UNITED STATES PATENT AND TRADEMARK OFFICE

10/551,629

Office Action Summary	Application No. 10/551,629	Applicant(s) KOHDA, TORU	
	Examiner Jay R. Ripley	Art Unit 3679

DETAILED ACTION

(Meeske Figure 1 and Figure 2)

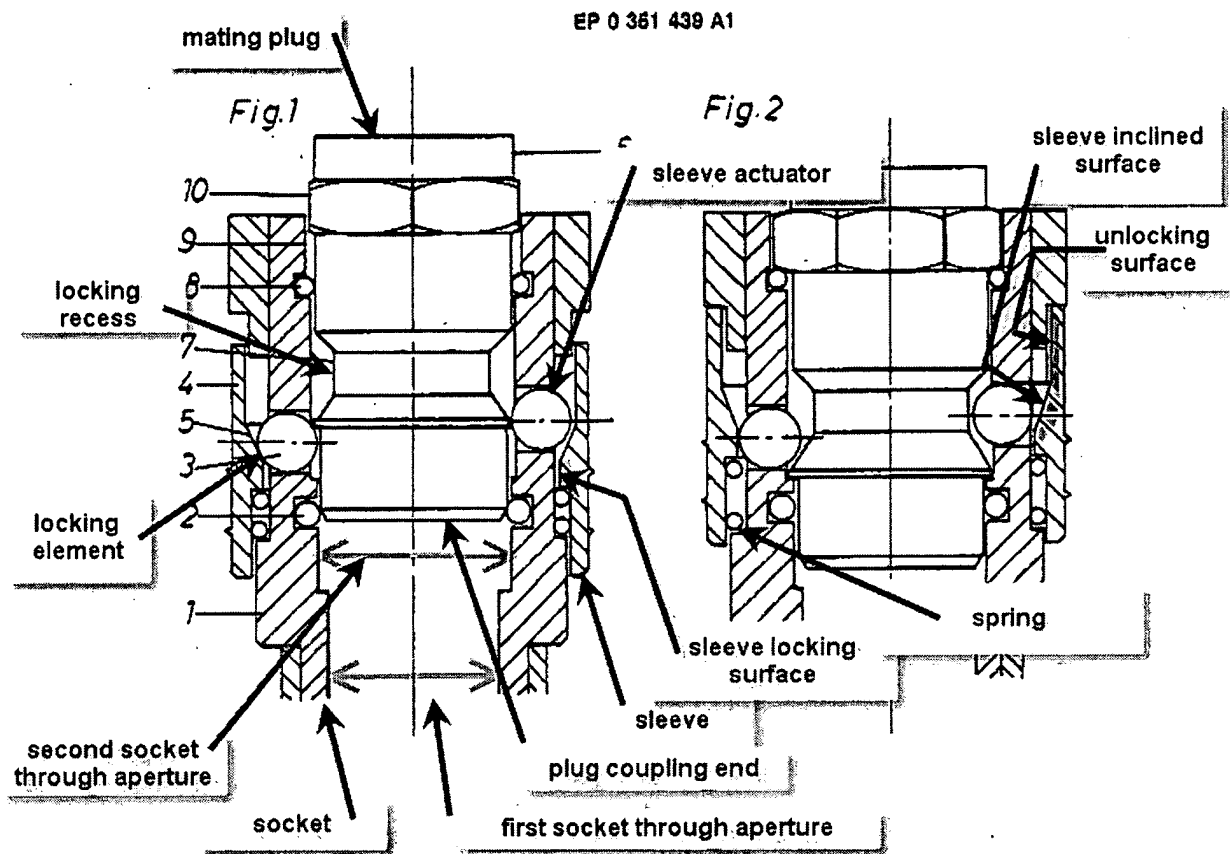
In regard to claims 3 and 8, Meeske discloses in Figure 1 and Figure 2, below, a pipe coupling comprising

a cylindrical socket body (1) having a first through aperture extending radially therethrough (as observed in Figure 1, below);

a locking element (the ball 3 furthest from the plug in Figure 1, below) radially movable within the first through aperture, the locking element being movable between a first radial position wherein the locking element is engaged with a locking recess (7) on the plug (as observed in Figure 2 and column 2, lines 31-35) so as to inhibit disconnection of the plug from the socket and a second radial position wherein the locking element is radially outwardly displaced from the first radial position and disengaged from the locking recess (as observed in Figure 1) to allow disconnection of the plug from the socket;

a sleeve (4) disposed around the socket body and having a locking surface (as observed in Figure 1, below) adapted to hold the locking element against radial outward movement (as observed in Figure 1, below) and prevent movement of the locking element from the first radial position to the second radial position and an unlocking surface adapted to allow movement of the locking element from the first radial position to the second radial position, the sleeve being axially movable (as observed when comparing Figure 1 and Figure 2) between a locking position wherein the locking surface is positioned radially outwardly of the locking element and an

a spring (as observed in Figure 1, below) for biasing the sleeve toward the locking position,

a coupling end directed toward the socket (as observed in Figure 1, below); and

a cylindrical surface extending from the coupling end in a direction away from the socket, the locking recess (as observed in Figure 1, below) being defined on the cylindrical surface,

the coupling end of the plug being slidably engaged with the locking element located in the first radial position to cause radial outward movement of the locking element when the plug is inserted into the socket (as observed in Figure 1),

the socket body comprises a second through aperture (as observed in Figure 1, below) located axially closer to the plug than the first through aperture and extending radially therethrough and a sleeve actuator (as observed in Figure 1, below) disposed in the second through aperture and movable between a radially inward position wherein the sleeve actuator is engaged with the coupling end of the plug upon insertion of the plug into the socket and a radially outward position wherein the sleeve actuator is located radially outwardly from the radially inward position (as observed in Figure 1, below); and

the sleeve has an inclined surface (as observed in Figure 1, below) inclined radially outwardly from the locking surface toward the unlocking surface, the inclined surface being engaged with the sleeve actuator when the sleeve is located in the locking position, the coupling end of the plug being engaged with the sleeve actuator upon insertion of the plug into the socket so that the sleeve actuator is radially outwardly moved to thereby cause axial movement of the sleeve against the bias of the spring and, thus, when the coupling end of the plug is brought into engagement with the locking element during advancement of the plug, the inclined surface is positioned at a radially outward position relative to the locking element, the coupling end of the plug radially outwardly urging the locking element against the inclined surface of the sleeve upon further insertion of the plug, thereby causing further axial movement of the sleeve (the invention of Meeske has the structure to so perform the functional recitation as can be observed in Figure 1 and Figure 2, below).

Meeske discloses the claimed invention except for the sleeve comprising two sleeve elements and a stopper feature. Wayne teaches a pipe coupling with locking elements (6, 7) in Figure 1, below, wherein the sleeve comprises two elements (5, 8) to provide a quick disconnection of the coupling with a releasable locking sleeve (column 1, lines 38-41). As Wayne relates to pipe couplings with locking elements, it would have been obvious to one having ordinary skill in the art at the time the invention was made to modify the pipe coupling of

(Wayne Figure 1)

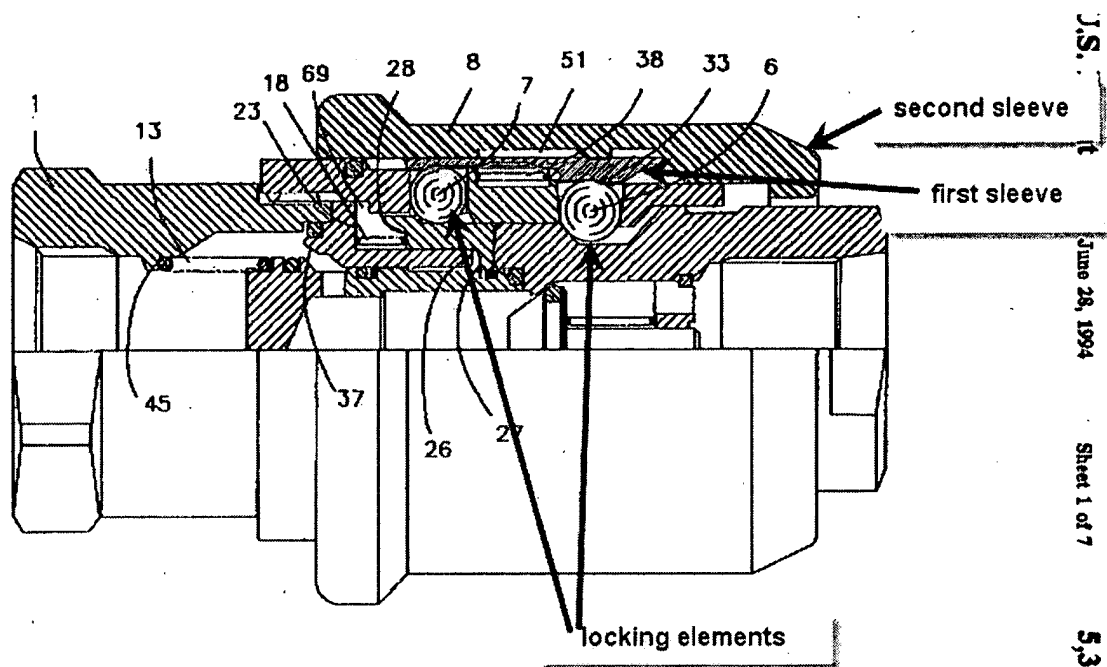
Meeske with the sleeve comprising two sleeve elements as taught by Wayne to provide a quick disconnection of the coupling with a releasable locking sleeve.

(Mullins Figure 6 and Figure 7)

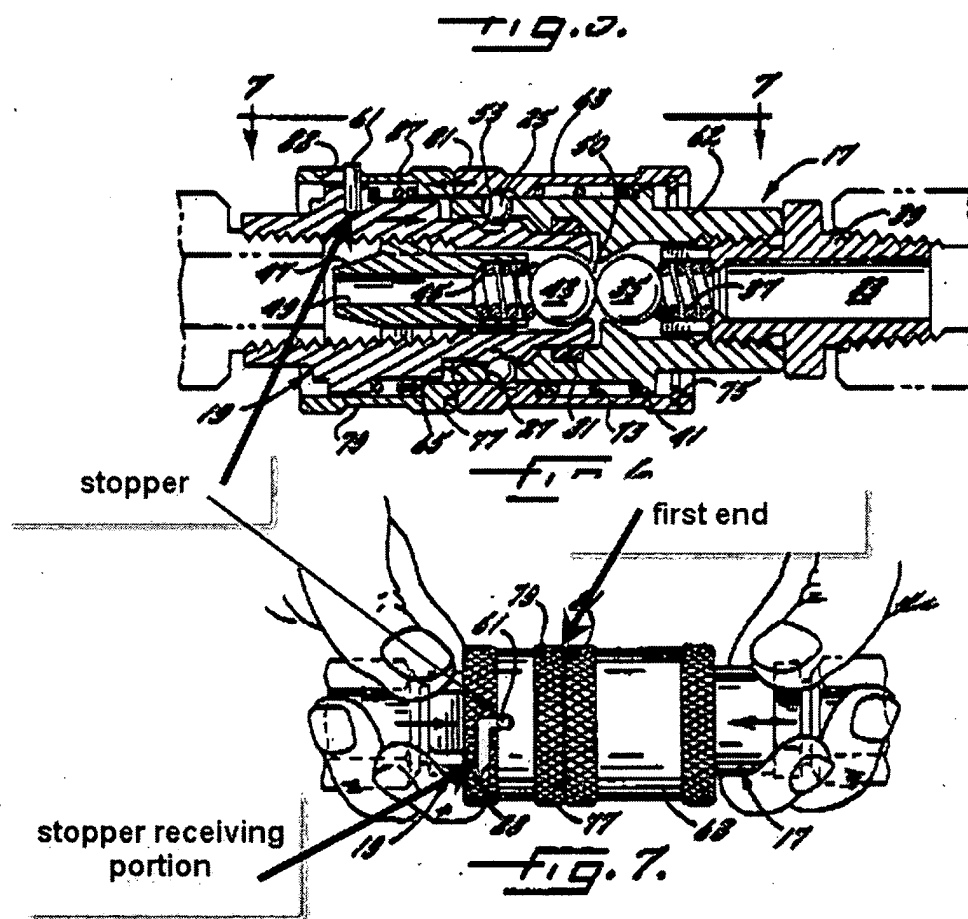
Further in regard to claims 3 and 8, Meeske in view of Wayne provide for the claimed invention except for a stopper feature. Mullins teaches a pipe coupling with locking elements in Figure 6 and Figure 7, below, with a stopper structure (pin 61 and slot 88) arranged on a coupling member, the stopper allowing a spring biased sleeve (79) to rotate between two angular positions and prevent axial movement of the sleeve at one of the axial positions (column 7, lines 48-52), to substantially preclude inadvertent uncoupling of the plug and the socket from coaxial relation (column 7, lines 45-52). As Mullins relates to pipe couplings with locking

elements, it would have been obvious to one having ordinary skill in the art at the time the invention was made to modify the sleeve as provided for by Meeske in view of Wayne with the stopper structure as taught by Mullins to substantially preclude inadvertent uncoupling of the plug and the socket from coaxial relation

In regard to claims 6, 9, 10, and 11, Mullins, in Figure 6 and Figure 7, above, provides:
the sleeve (79) having a first end adjacent to the plug (19) and a second end remote from the plug,

wherein the stopper receiving portion includes a slot (88) extending from the second end toward the first end of the second sleeve,

wherein the stopper (61) extends radially outwardly from the fitting (as observed in Figure 6)

(Wayne cut-out of Figure 1)

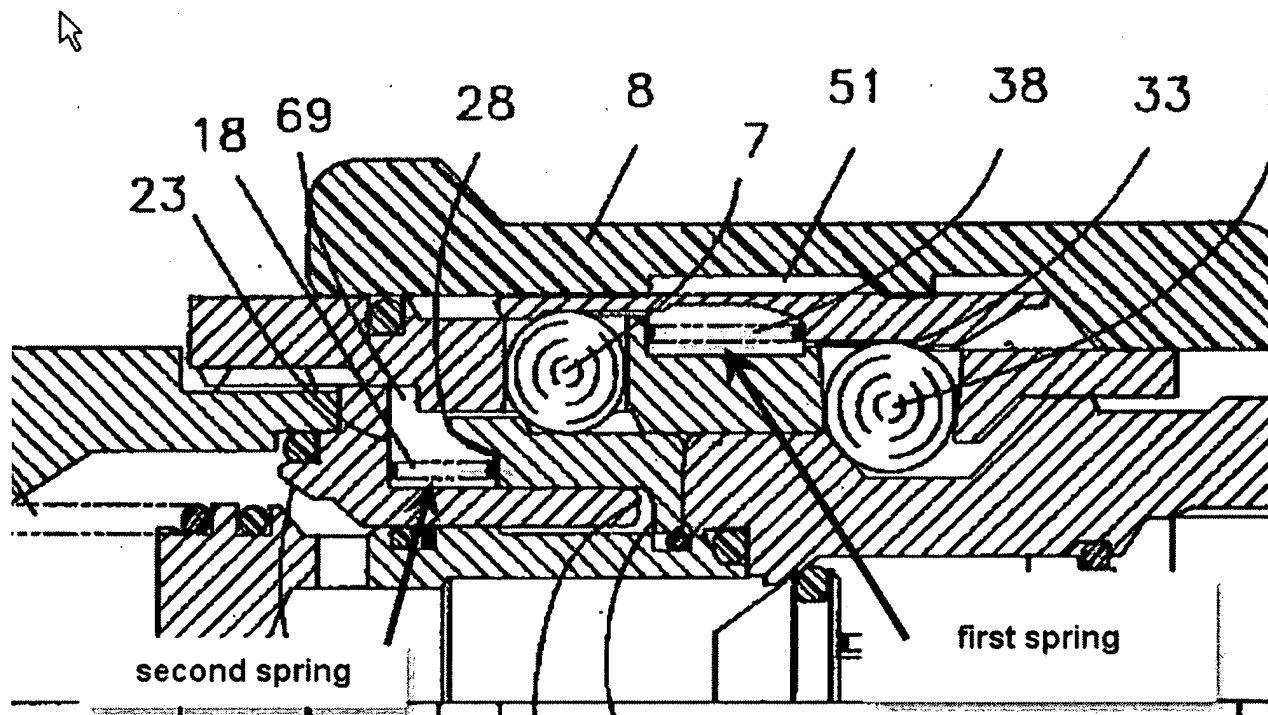
In regard to claim 4, Meeske in view of Wayne and Mullins provide for the claimed invention including a second spring. Wayne also teaches a second spring (18), as observed in cut-out of Figure 1, below, to urge the sleeve toward the locked position (column 4, lines 18-20). As Wayne relates to pipe couplings with locking elements, it would have been obvious to one having ordinary skill in the art at the time the invention was made to further modify the pipe coupling as provided by Meeske in view of Wayne and Mullins with a second spring as further taught by Wayne to urge the sleeve toward the locked position.

(Meeske cut-out of Figure 1)

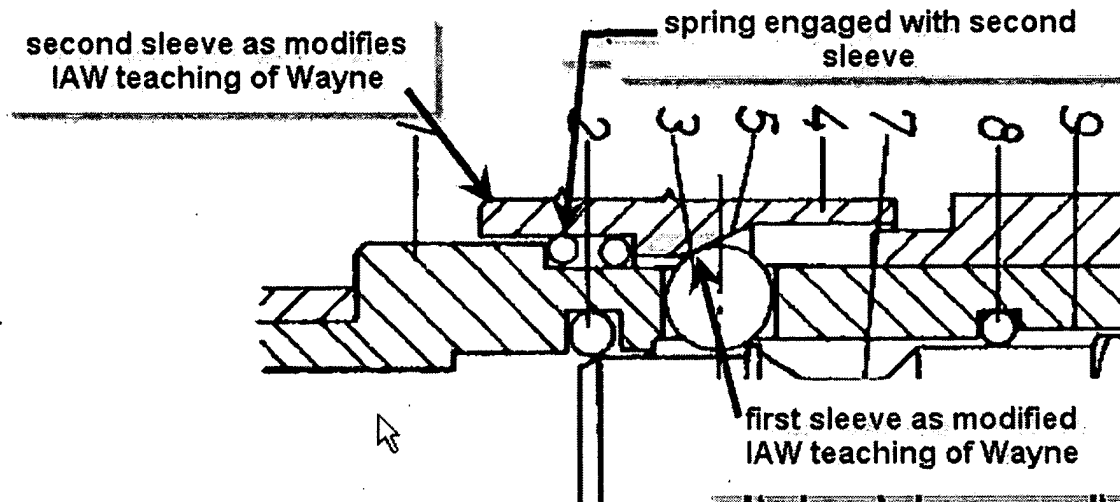
In regard to claim 5, Meeske further provides for a coil spring disposed around the socket body having one end located at one position on the socket body and engaged with the first sleeve to urge the first sleeve toward the locking position, and an other end engaged with the second

sleeve (a coil spring as indicated by the symbol used in Meeske Figure 1, a cut-out shown below, the recognized technical drafting symbol for a coil spring).
